S206-R166

### Unintended Rear Wheel Braking – No Park Brake Warning Lights Displayed – RECALL R166

S206-R167

**Unintended Rear Wheel Braking –  
Park Brake Warning Lights Displayed –  
RECALL R167**

ILLUSTRATION 2

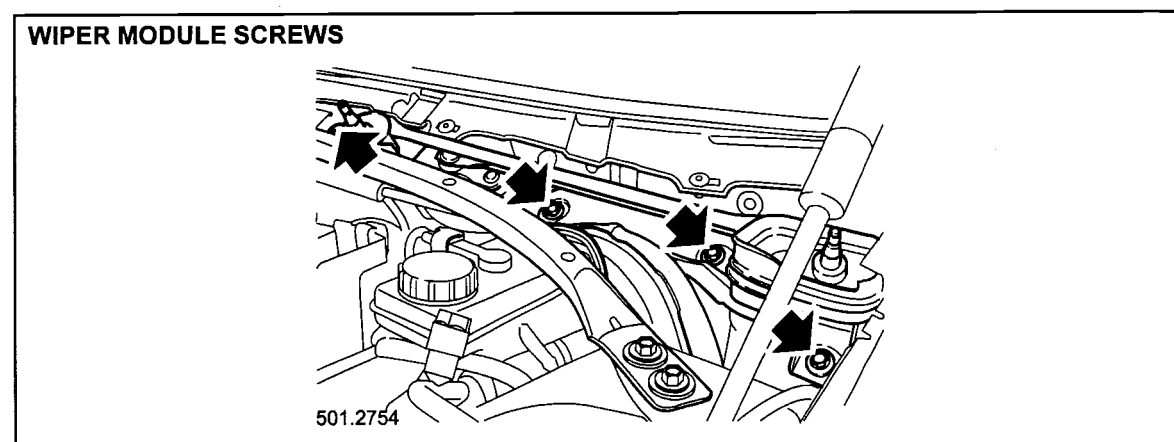
7. Remove the wiper assembly securing screws, Illustration 2

15. Install the wiper assembly securing screws (Illustration 2). Torque to 15 Nm (11 lb-ft.)
16. Reposition and seat the drain tube in the inner fender.

ILLUSTRATION 3

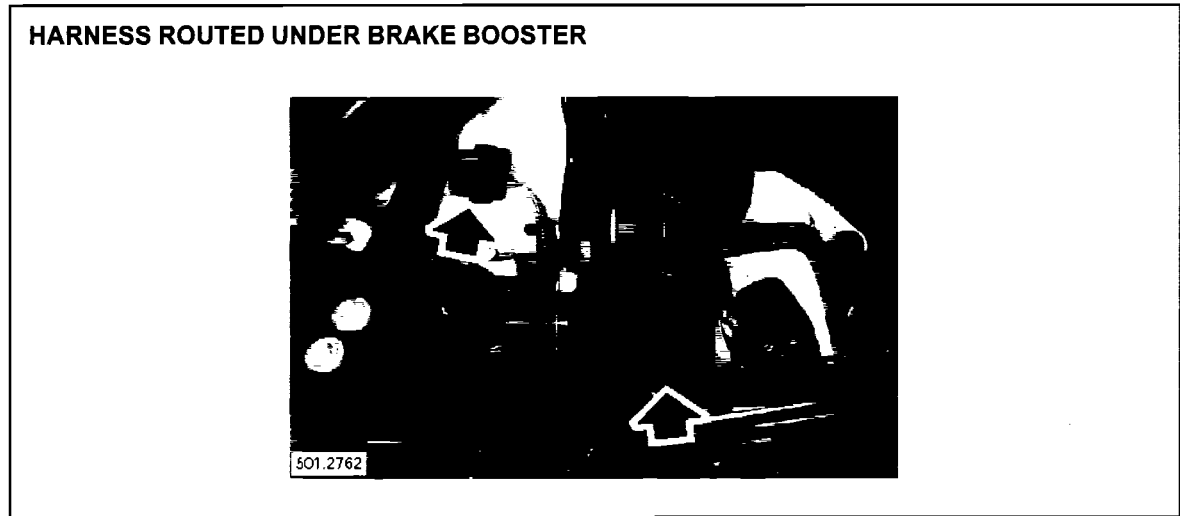
10. Route the wiper motor electrical harness under the brake booster, Illustration 3.

ILLUSTRATION 5

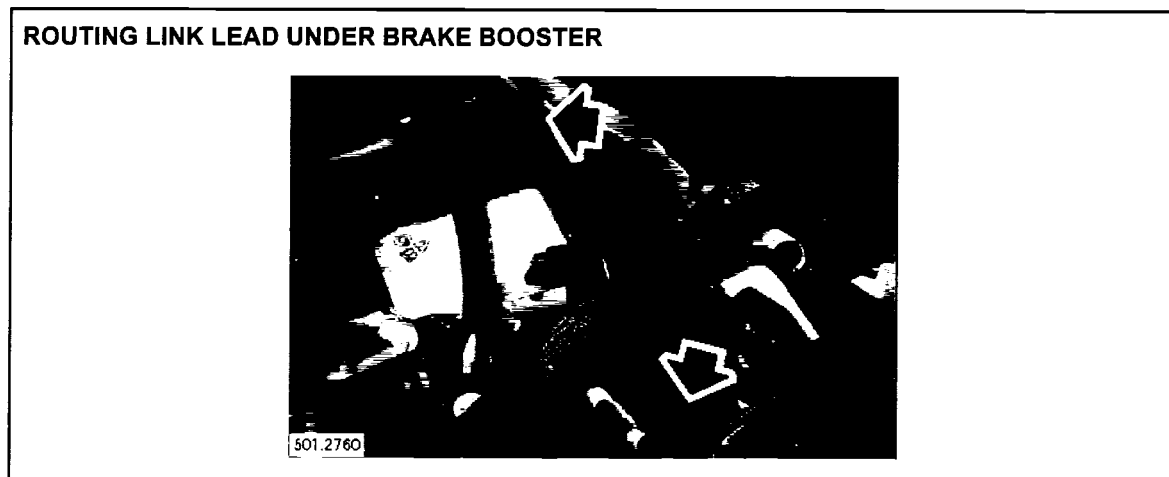
12. Route the link lead under the brake booster as in Illustration 5.

ILLUSTRATION 6

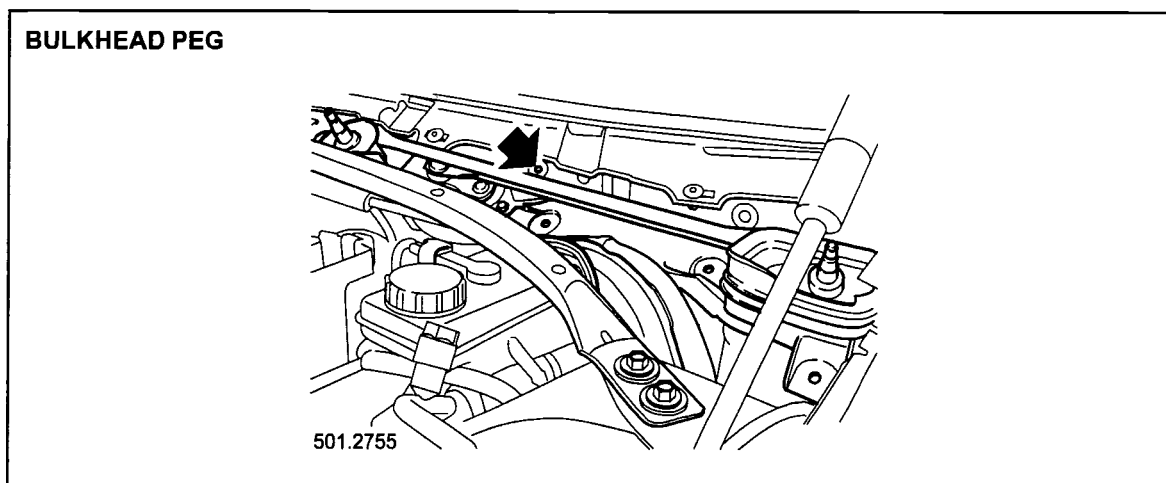
13. Connect the link lead electrical connector to the wiper motor.
14. Reposition and align the wiper assembly. (Make sure the assembly engages the bulkhead peg, Illustration 6).

ILLUSTRATION 7

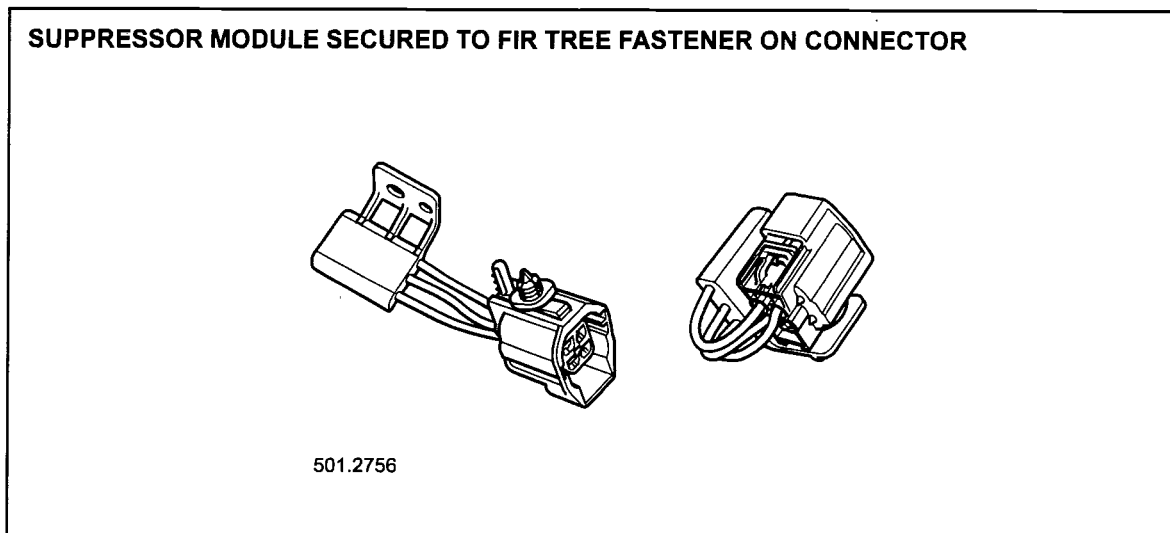
17. Secure the new suppressor module to the fir tree fastener of its electrical connector as shown in Illustration 7.

ILLUSTRATION 9

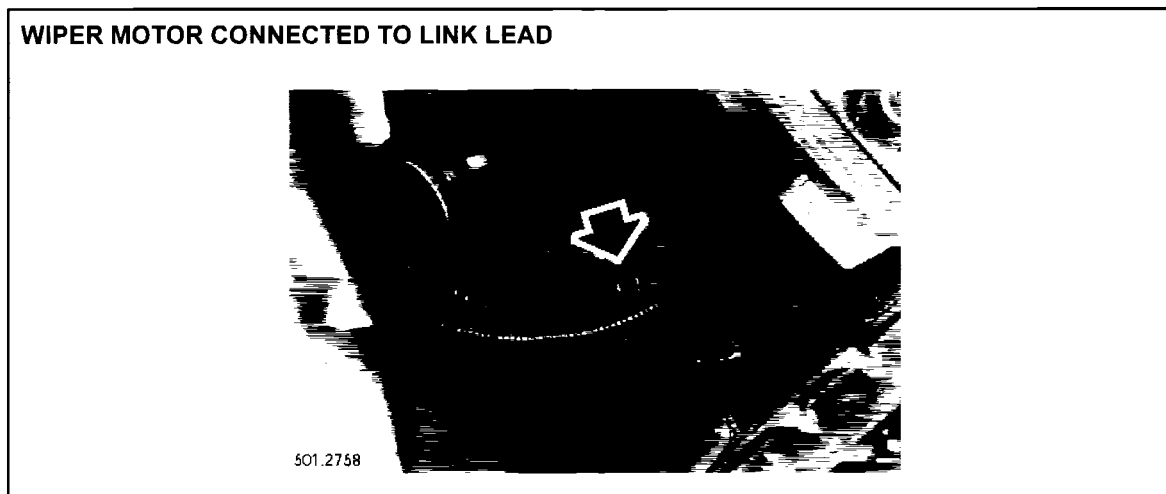
20. Connect the electrical connector of the vehicle wiper motor to the electrical connector of the link lead, Illustration 9.

ILLUSTRATION 11

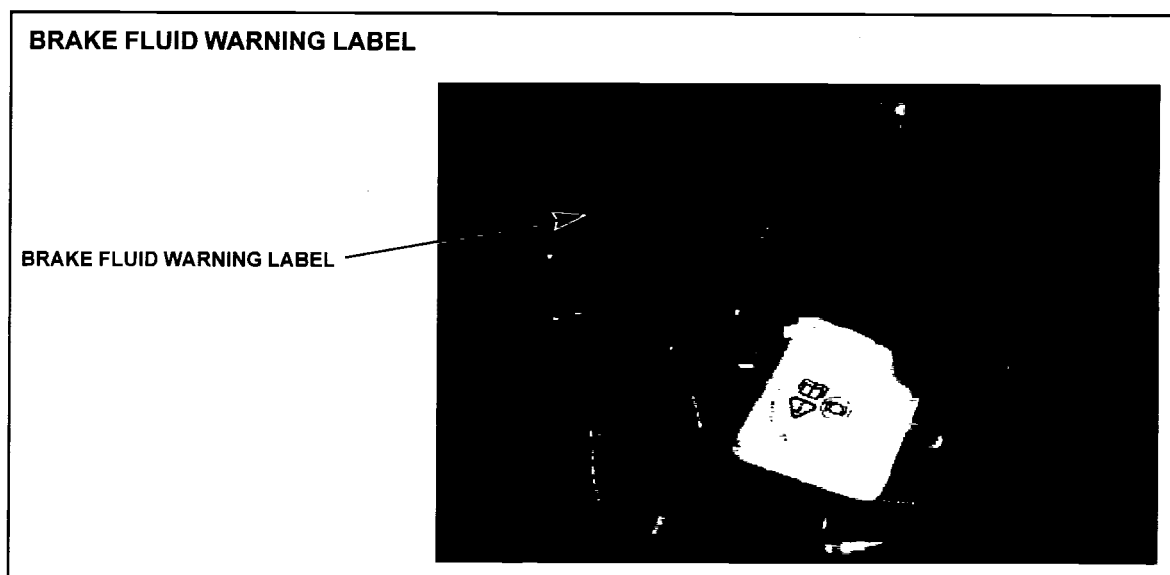
24. Clean the plenum chamber finisher and apply a new brake fluid warning label (Illustration 11) to complete Recall R171.
